1962 Corvette: Service Bulletin: Aluminum Powerglide Shift Problems

Source: Chevrolet Technical Service Bulletin

Bulletin No: DR #514

Date: January 16, 1962

FIGURE 1- 327 AND 283 POWERGLIDE TV LINKAGE COMPARISON

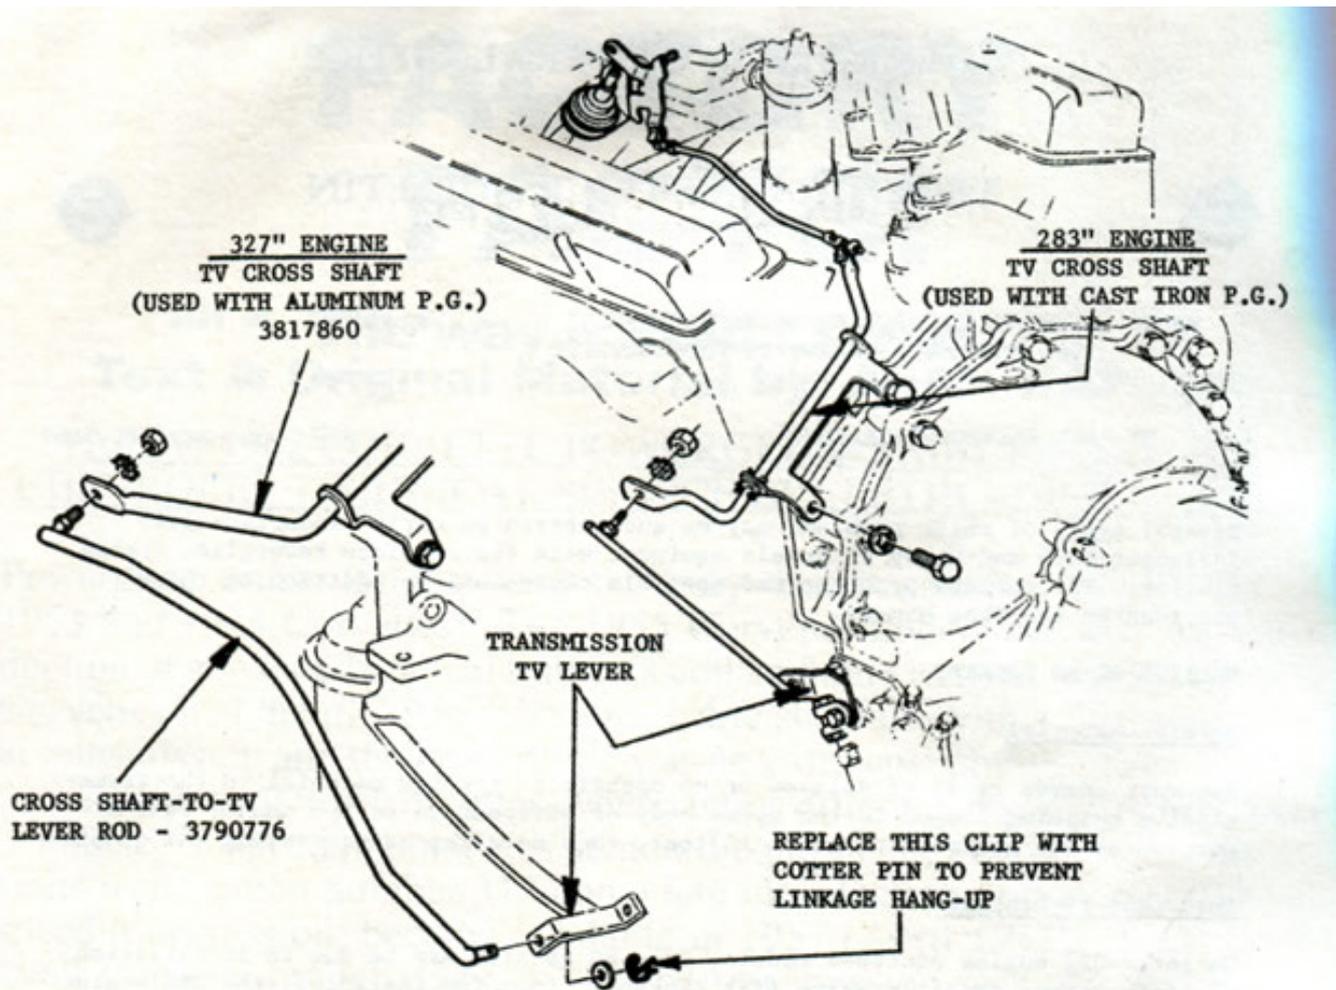
Incorrect TV Linkage

On early 327 engine equipped models, delayed upshift may be due to installation of an incorrect throttle valve (TV) linkage. In a few instances, the 283 engine cross shaft was installed instead of the correct TV cross shaft, 3817860. The TV cross shaft are easily identified as the 283 version has a bend in its outboard lever whereas the 327 cross-shaft lever is straight in this same area. (Figure 1). If the TV cross shaft was incorrect, also check the cross shaft-to-TV lever rod. As shown in Figure 1, this rod, 3790776, is formed on 327 engine applications as compared to the straight rod used on 283 engine versions.

Cross Shaft, TV (327 engine) ---- 3817860

Rod, Cross Shaft-to TV (327 engine) ----- 3790776

FIGURE 2 - ALUMINUM POWERGLIDE DIPSTICKS

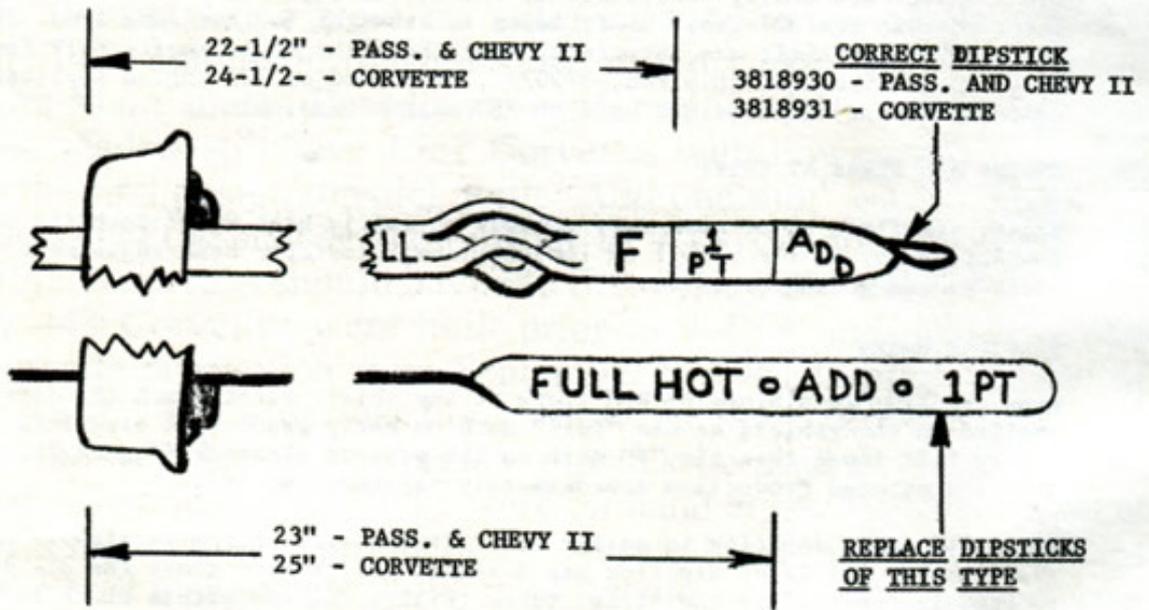
When checking complaints of RPM flare at the shift, first check the dipstick installed in the vehicle as the "Full" mark on early production dipsticks is approximately 1/2" lower than the "F" mark on the present dipstick (Figure 2). The later dipstick entered Production approximately September 4, 1961.

The early style dipstick is easily identified as its bottom section is absolutely flat whereas the later dipstick has a formed bridge just above the oil level markings to keep it centered in the filler tube. (Figure 2). A further check is to measure the distance from the top of the cap to the "Full" mark; on

Passenger and Chevy II dipsticks, this distance is now 22-1/2", as compared to 23" on the earlier dipsticks. This distance on the Corvette dipstick is now 24-1/2" as compared to 25" on earlier units.

Replace all early dipsticks with the later part when found and add oil as

required to raise the transmission oil level to the "F" mark. The later dipstick for 327 engine passenger cars and all Chevy II Models is 3818930; for Corvette, 3818931.
